Federal Emergency Management Agency

IN REPLY REFER TO:
Case No.: 97-06-776P

Community: City of Albuquerque, New Mexico
Community No.: 350002
Panels Affected: 35001C0358 D, 0359 D,
and 0367 D
Effective Date of
This Revision: JUL 16 1997

This responds to a request that the Federal Emergency Management Agency (FEMA) revise the effective Flood Insurance Rate Map (FIRM) for Bernalillo County, New Mexico and Incorporated Areas (the effective FIRM for your community), in accordance with Part 65 of the National Flood Insurance Program (NFIP) regulations. In a letter dated June 3, 1997, Ms. Susan M. Calongne, P.E., City/County Floodplain Administrator, City of Albuquerque/Bernalillo County, requested that FEMA revise the FIRM to show the effects of the Juan Tabo Detention Basin at the northwest corner of the intersection of Juan Tabo Boulevard and Singing Arrow Avenue. This request follows up on a Conditional Letter of Map Revision issued on July 23, 1996.

FIRM

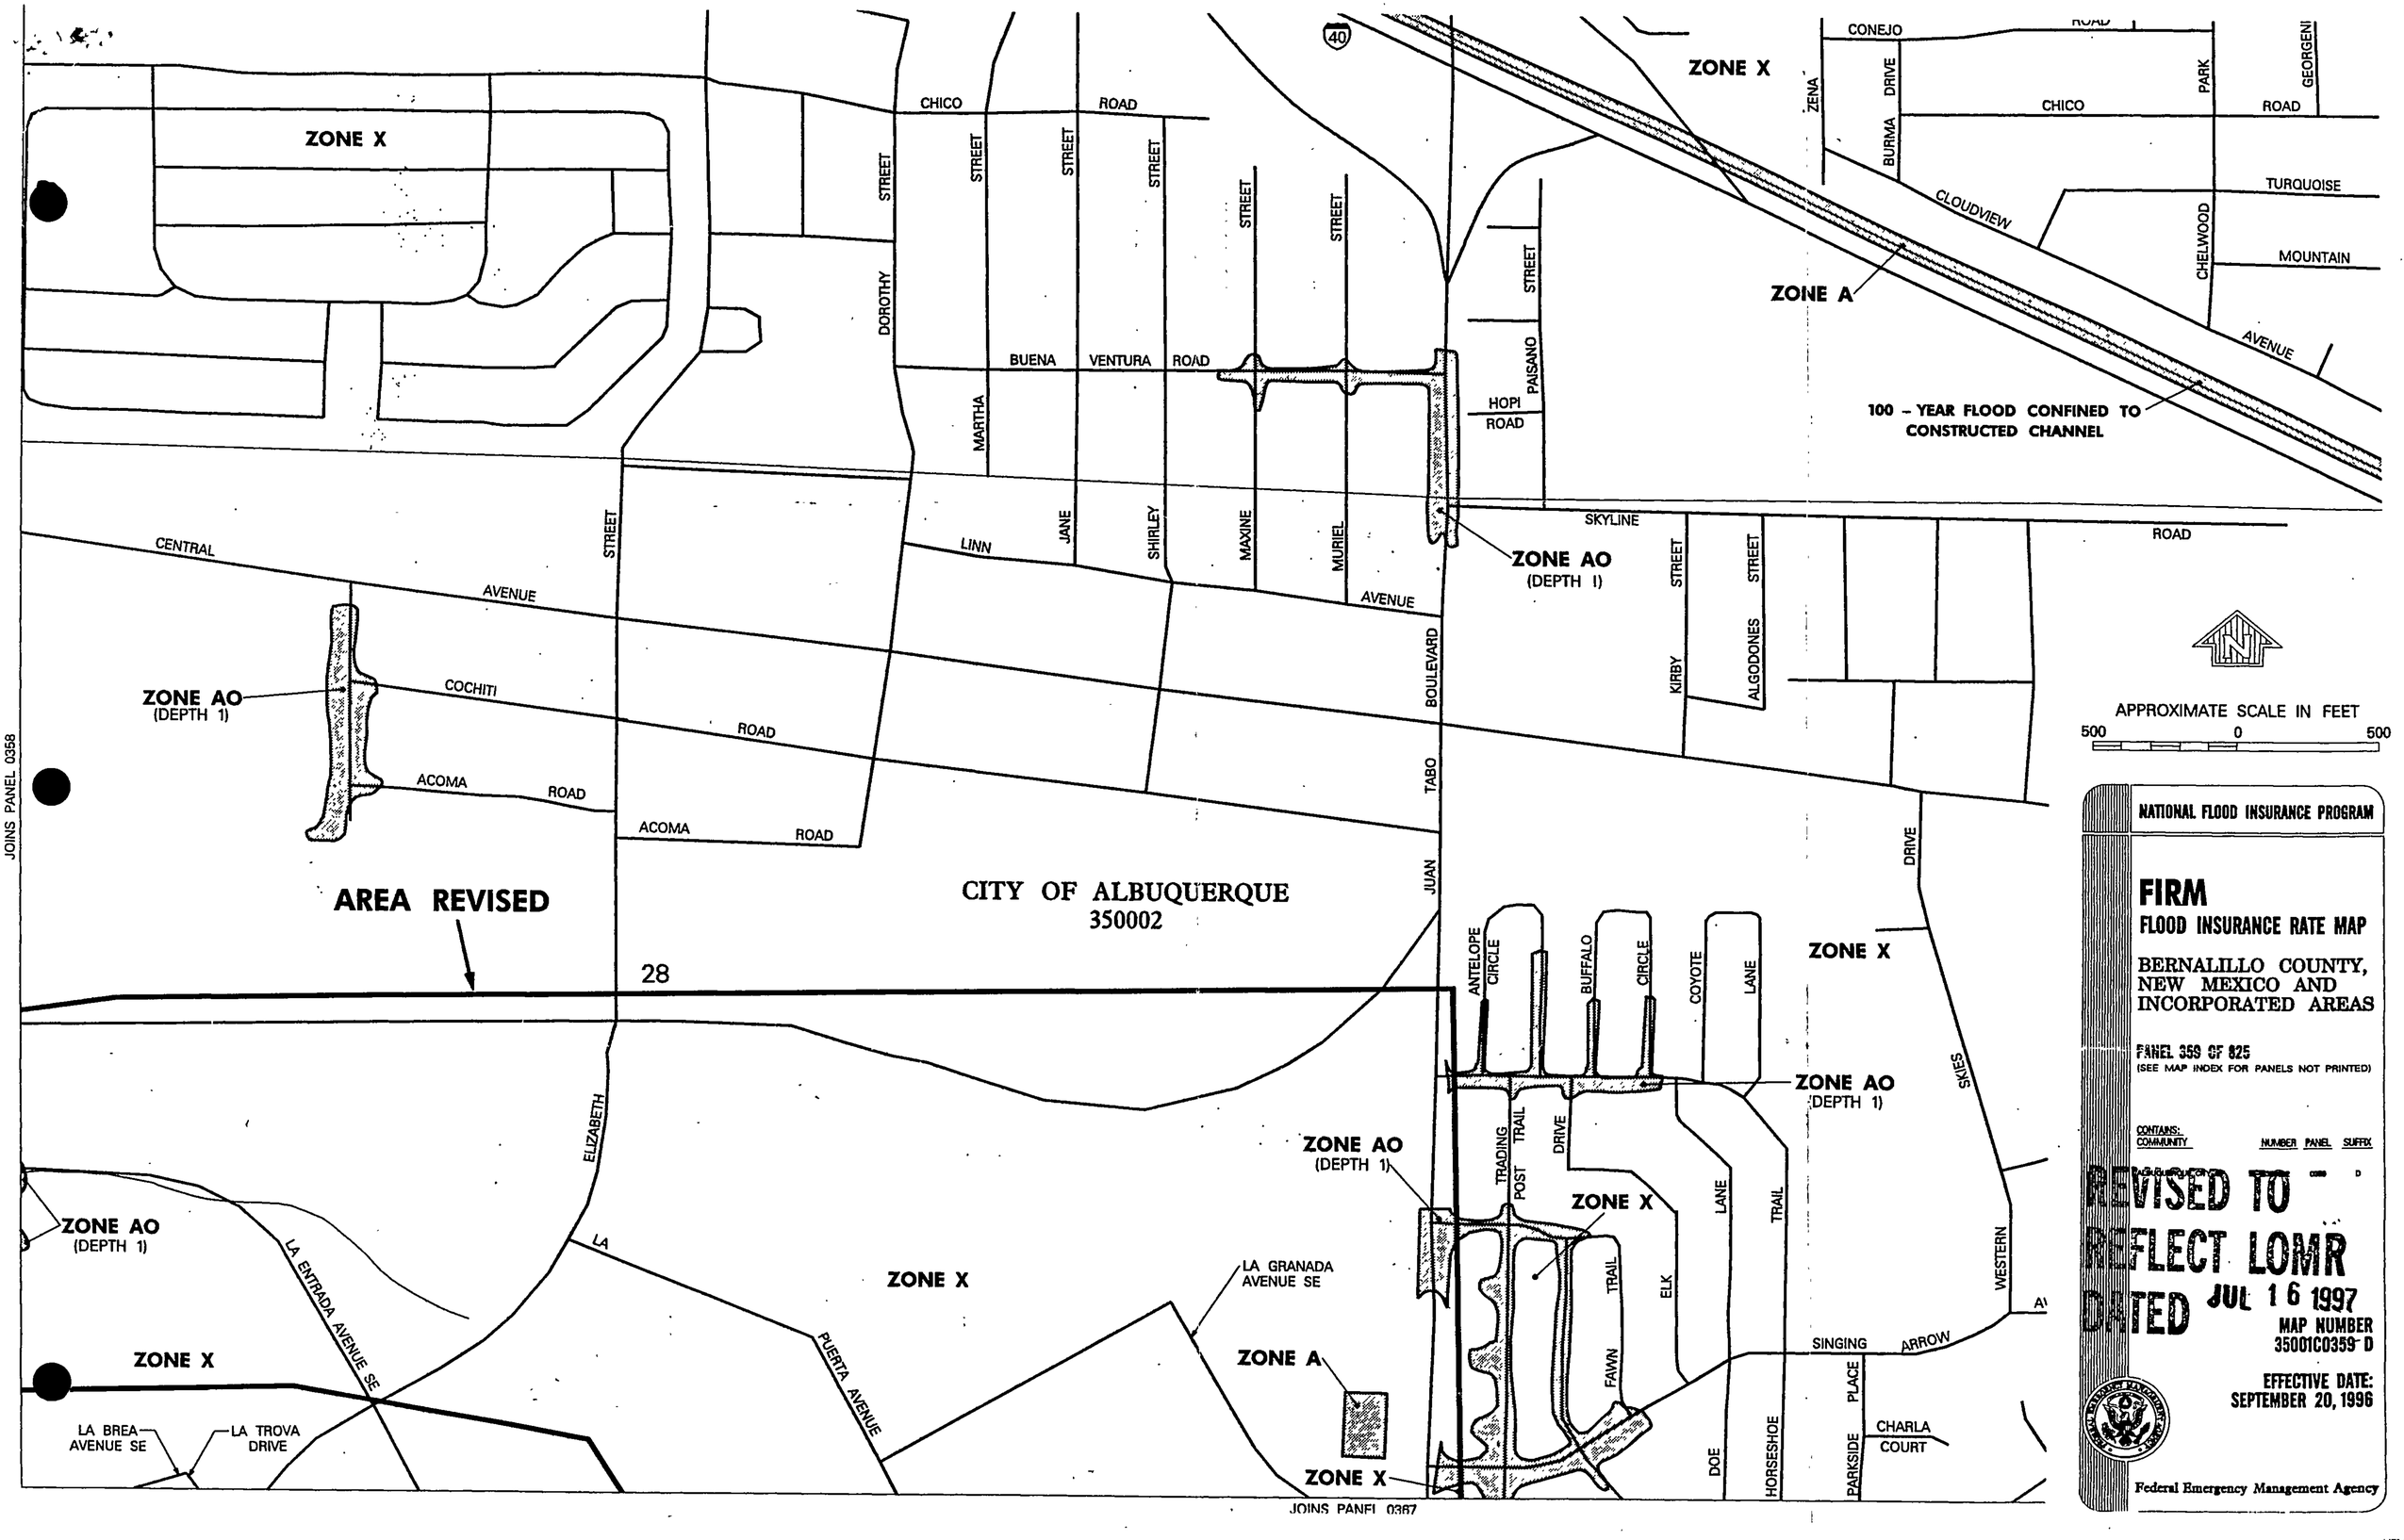
We have completed our review of the submitted data and the flood data shown on the effective FIRM. We have revised the FIRM to modify the elevations and floodplain boundary delineations of the flood having a 1-percent chance of being equaled or exceeded in any given year (base flood) in the area bordered by Bucking Bronco Trail to the south, Juan Tabo Boulevard to the east, Southern Avenue to the north, and Eubank Boulevard to the west. As a result of the modifications, the Special Flood Hazard Area (SFHA) designated Zone AO, the area that would be inundated by the base flood with average depths between 1 and 3 feet, was removed from the area described above, except for two small ponding areas along Eubank Boulevard, one approximately 600 feet south of Southern Avenue and the other at the intersection of Elizabeth Street. In addition, the SFHA designated Zone AO along Juan Tabo Boulevard between Horseshoe Trail and Southern Avenue was removed, except the area from the intersection of Fawn Trail and Juan Tabo Boulevard to approximately 300 feet south of the intersection. The SFHA increased only along the boundaries of the Juan Tabo Detention Basin. The Juan Tabo Detention Basin is designated Zone A, the area that would be inundated by the base flood, with base flood elevations not determined. The modifications are shown on the enclosed annotated copies of FIRM Panel(s) 35001C0358 D, 0359 D, and 0367 D. This Letter of Map Revision (LOMR) hereby revises the above-referenced panel(s) of the effective FIRM dated September 20, 1996.

Location	Existing BFE (feet)*	Modified BFE (feet)*
Intersection of Juan Tabo Boulevard and Singing Arrow Avenue	1	None
Intersection of Juan Tabo Boulevard and Horseshoe Trail	1	None
Intersection of La Puerta Avenue SE and La Vara Drive SE	1	None
